SERVICE BULLETIN REVISION NOTICE

NON-MODIFICATION SERVICE BULLETIN — ENGINE — PACKING — REMOVAL OF SUSPECT PACKINGS

Turbojet Engine Service Bulletin No. V2500-ENG-72-0663 Revision No. 1 dated October 2, 2017.

To correct Wire PN 4W2627 to Lockwire V02-126 within the Material Information and Accomplishment Instructions sections.

LOCATION OF TUBE 181
FIGURE 1

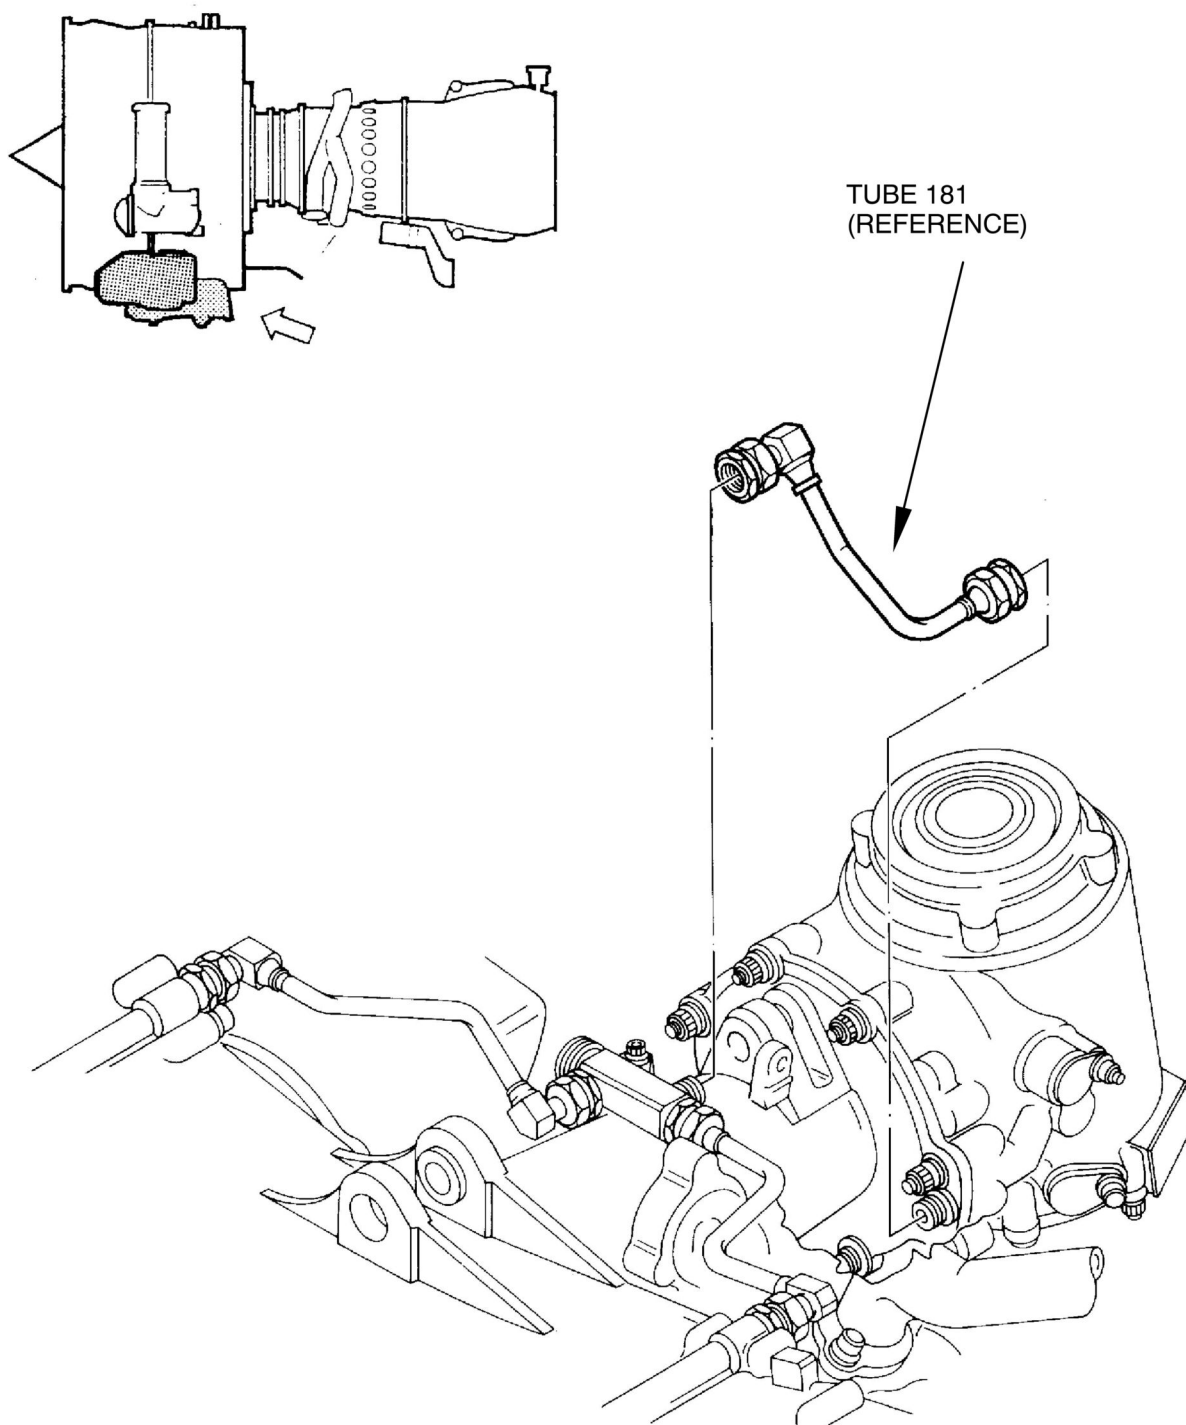
Instruction I - Procedure To Remove And Replace Packing PN AS3209-110 For Angle Gearbox, Tube 181 Location

1. Disconnect Tube 181 at the angle gearbox and at the distributor, and remove Tube 181. See Figure 1 and Figure 4.

2. Remove the oil input adapter from the front of the angle gearbox casing. See Figure 5.
 - A. Remove the two bolts which attach the oil input adapter to gearbox.
 - B. Remove the oil input adapter and packing. Save the packing and return to IAE.
3. Install new Packing, PN AS3209-110 into the groove of oil input adapter.
4. Install the oil input adapter into the seat of the angle gearbox. Align the holes in the adapter flange with the two threaded holes. See Figure 5.
5. Install the two bolts and torque to 85 to 95 Lbf.in (9.604 to 10.734 Nm)
6. Install Tube 181 between the angle gearbox and the distributor. Torque both ends of the tube to 204 to 221 Lbf.in (23 to 25 Nm). Safety with Lockwire, V02-126. See Figure 1 and Figure 4.

LOCATION OF TUBE 182
FIGURE 2

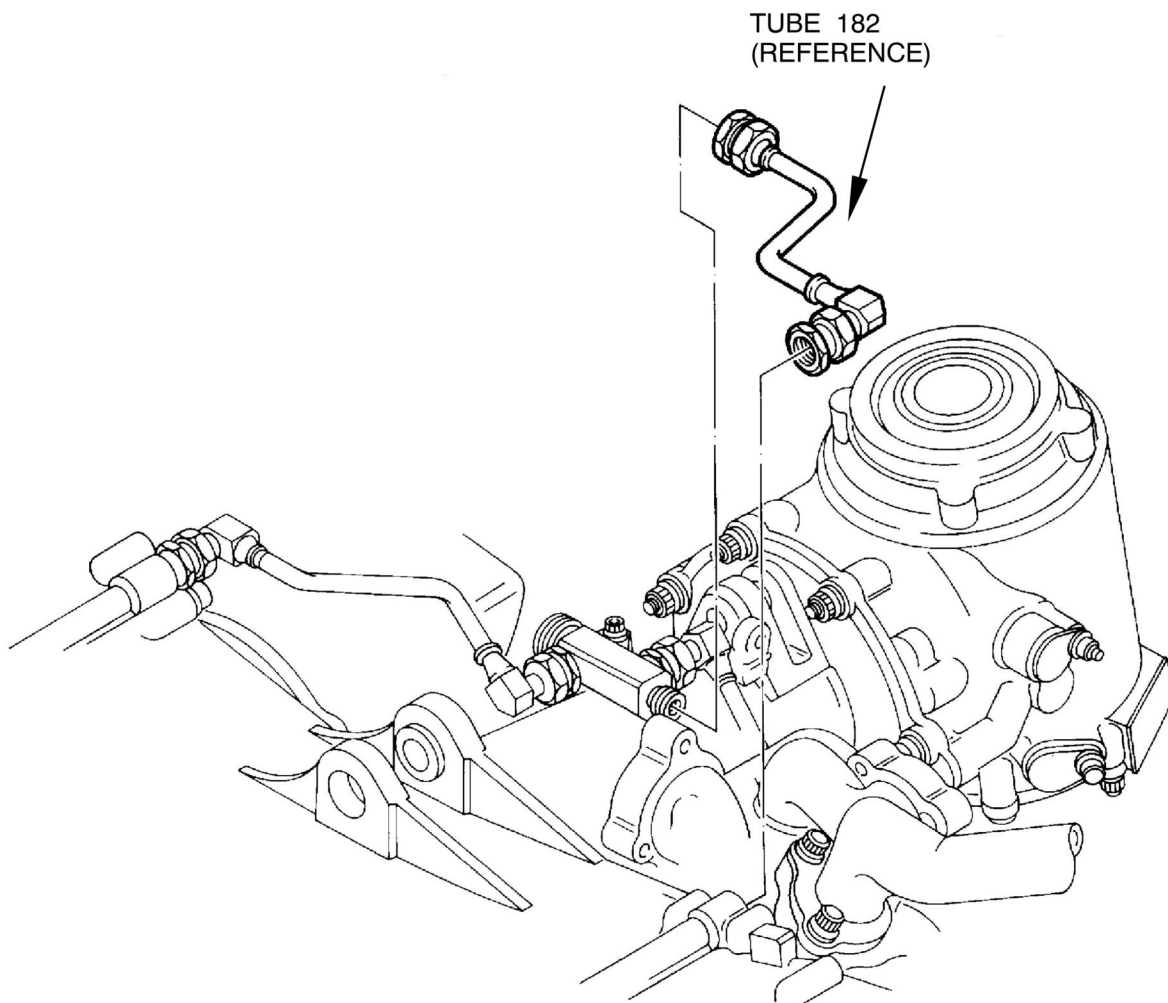
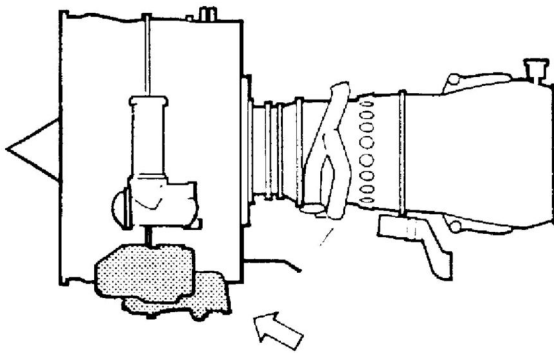
Instruction II - Procedure To Remove And Replace Packing PN AS3209-110 For Main Gearbox, Left Side, Tube 182 Location

2. Disconnect Tube 182 at the gearbox and at the distributor, and remove Tube 182. See Figure 2 and Figure 4.
NOTE: With an applicable tool, hold the distributor to prevent movement and remove Tube 182.

6. Install the two bolts and torque to 85 to 95 Lbf.in (9.604 to 10.734 Nm).
7. Install Tube 182 on the gearbox between the distributor and the gearbox, adjacent to the oil scavenge pump. Torque the both ends of the tube to 204 to 221 Lbf.in (23 to 25 Nm). Safety with Lockwire, V02-126. See Figure 2 and Figure 4.

LOCATION OF TUBE 183
FIGURE 3

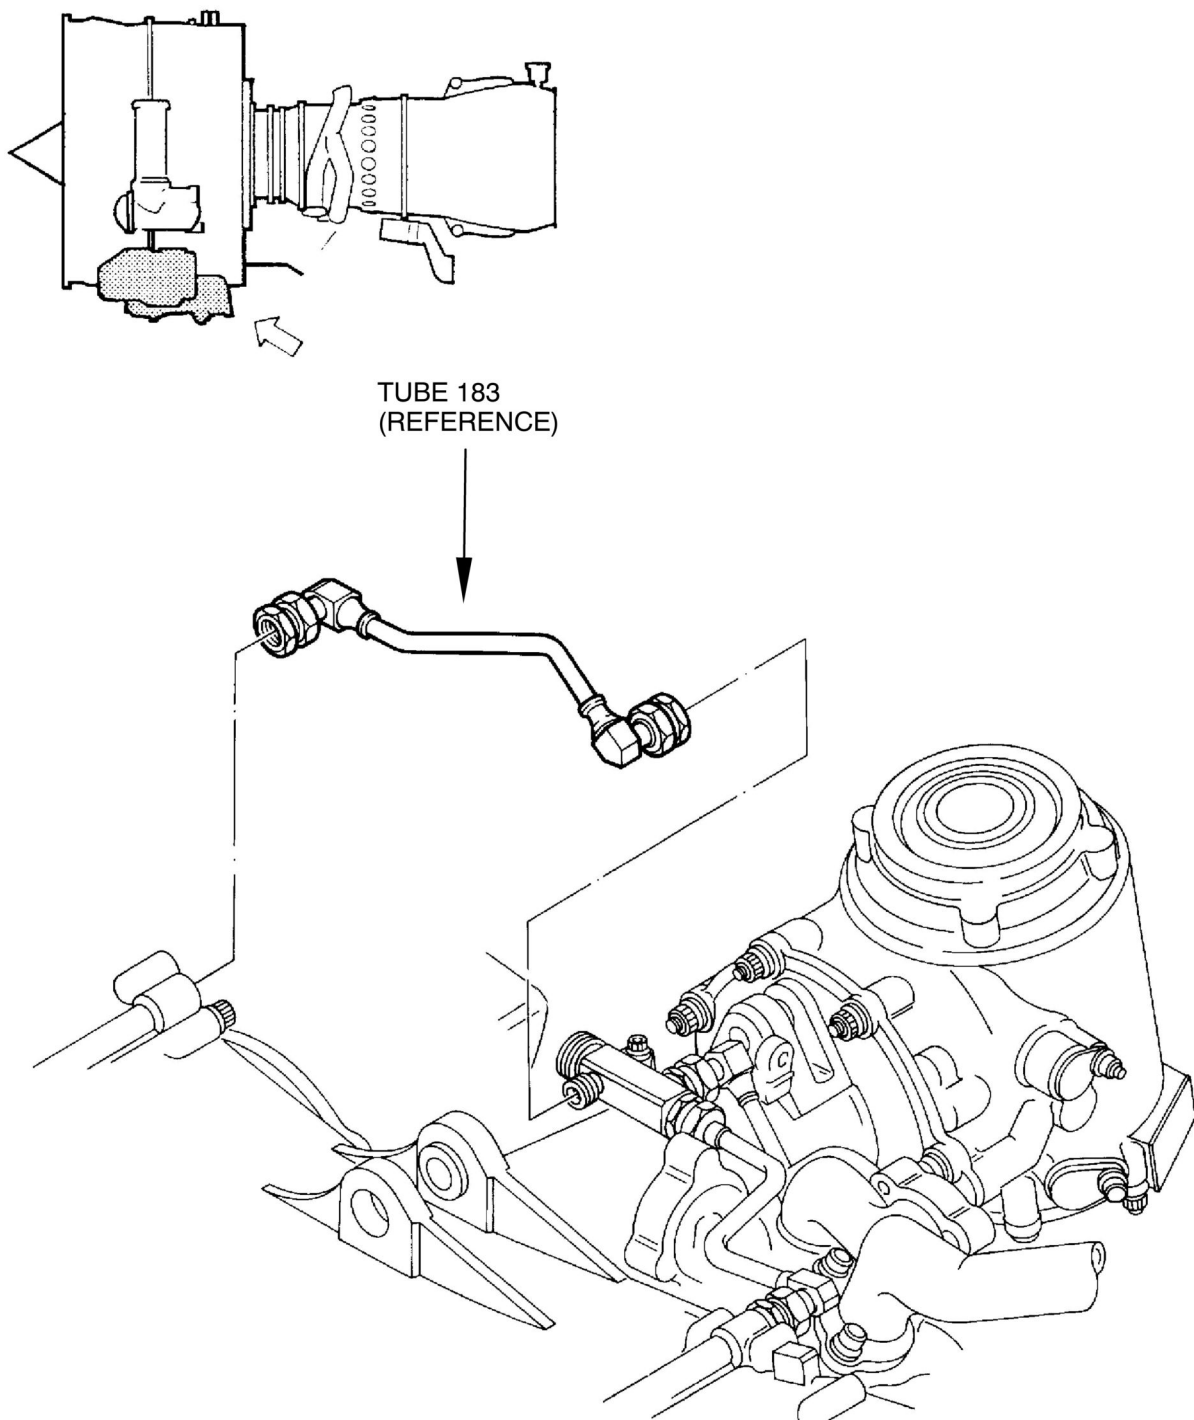
Instruction III - Procedure To Remove And Replace Packing PN AS3209-110 For Main Gearbox, Right Side, Tube 183 Location

1. Disconnect Tube 183 at the gearbox and at the distributor, and remove Tube 183. See Figure 3 and Figure 4.
NOTE: With an applicable tool, hold the distributor to prevent movement and remove Tube 183.

5. Install the two bolts and torque to 85 to 95 Lbf.in (9.604 to 10.734 Nm).
6. Install Tube 183 on the gearbox between the distributor and the gearbox, adjacent to the IDG. Torque both ends of the tube to 204 to 221 Lbf.in (23 to 25 Nm). Safety with Lockwire, V02-126. See Figure 3 and Figure 4.

LOCATION OF PACKING (TUBE 181)
FIGURE 5

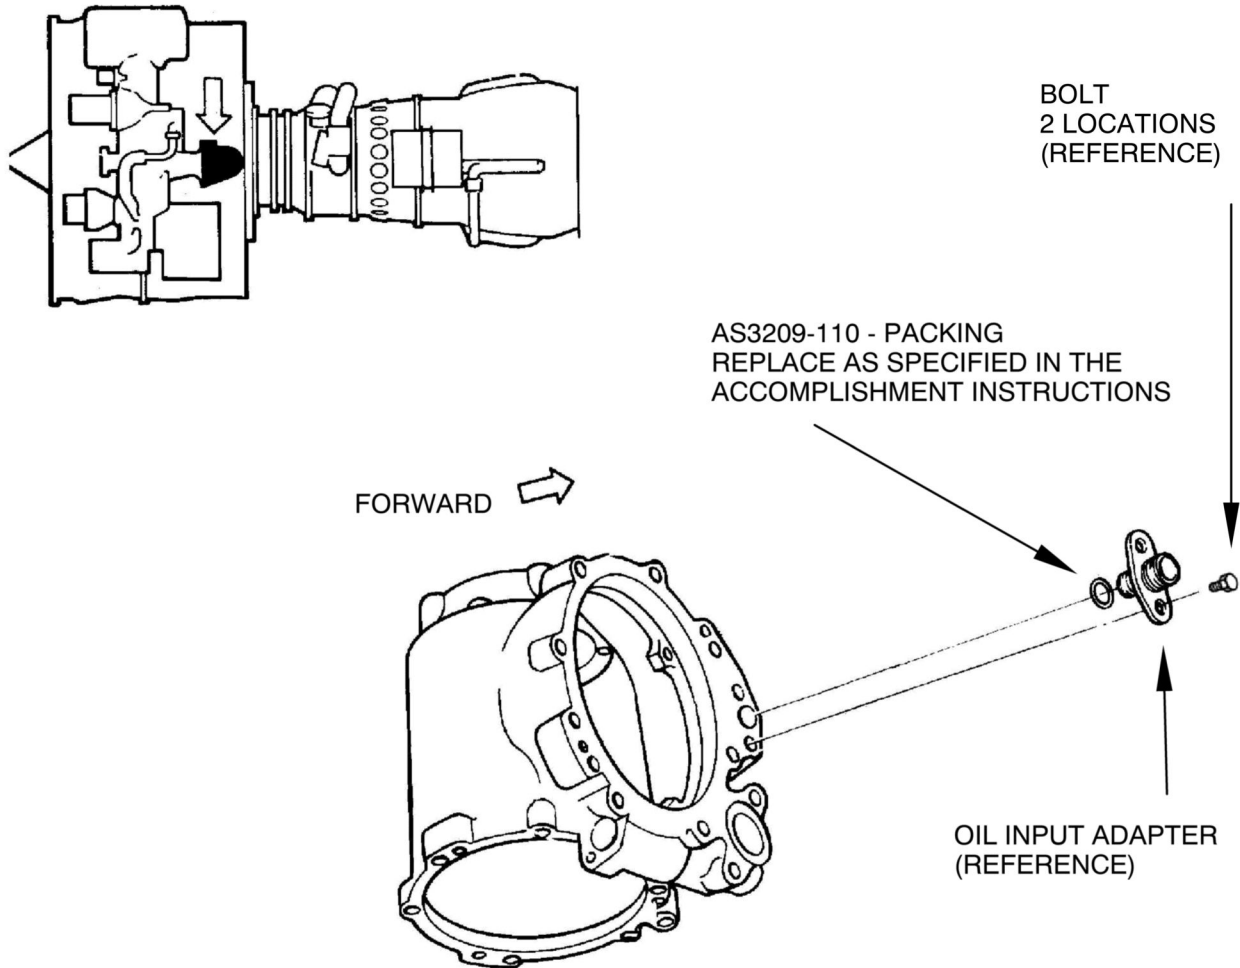
1. Replace Packing, PN AS3209-110 with new at the angle gearbox near Tube 181, Reference 5, EM Task 72-60-40-040-001 and Task 72-60-40-440-001. See Figure 5.
2. Replace Packing, PN AS3209-110 with new at gearbox left side near Tube 182, Reference 5, EM Task 72-60-21-040-001 and Task 72-60-21-440-001. See Figure 6.
3. Replace Packing, PN AS3209-110 with new at gearbox right side near Tube 183, Reference 5, EM Task 72-60-21-040-001 and Task 72-60-21-440-001. See Figure 6.
4. Perform an oil leak check, Reference 5, EM Task 71-00-00-700-003-B00.
5. Recording Instructions
 - A. A record of accomplishment is required.

LOCATION OF PACKING (TUBE 182 AND TUBE 183)
FIGURE 6

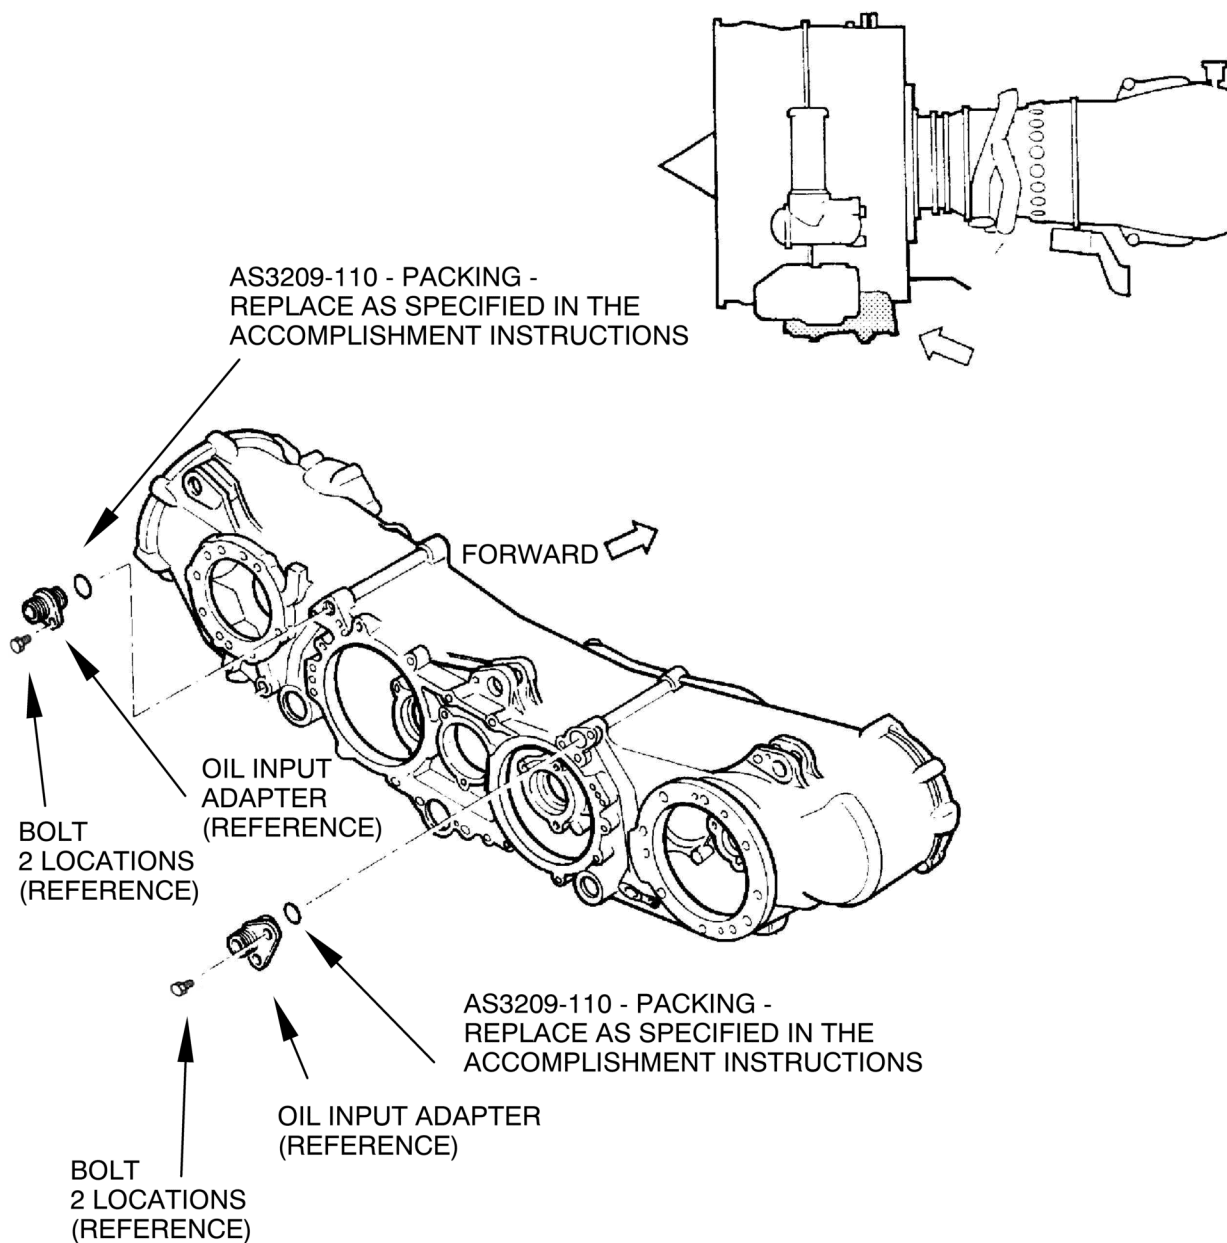
3. Remove the oil input adapter from the mounting flange of the gearbox (left side above oil scavenge pump). See Figure 6.
 - A. Remove the two bolts which attach the oil input adapter to gearbox.

5. Install the oil input adapter into the seat on the left hand side of the gearbox. Align the holes in the adapter flange with the two threaded holes. See Figure 6.

2. Remove the oil input adapter from the mounting flange of the gearbox (right side). See Figure 6.
 - A. Remove the two bolts which attach the oil input adapter to gearbox.

4. Install the oil input adapter into the seat on the right hand side of the gearbox. Align the holes in the adapter flange with the two threaded holes. See Figure 6.
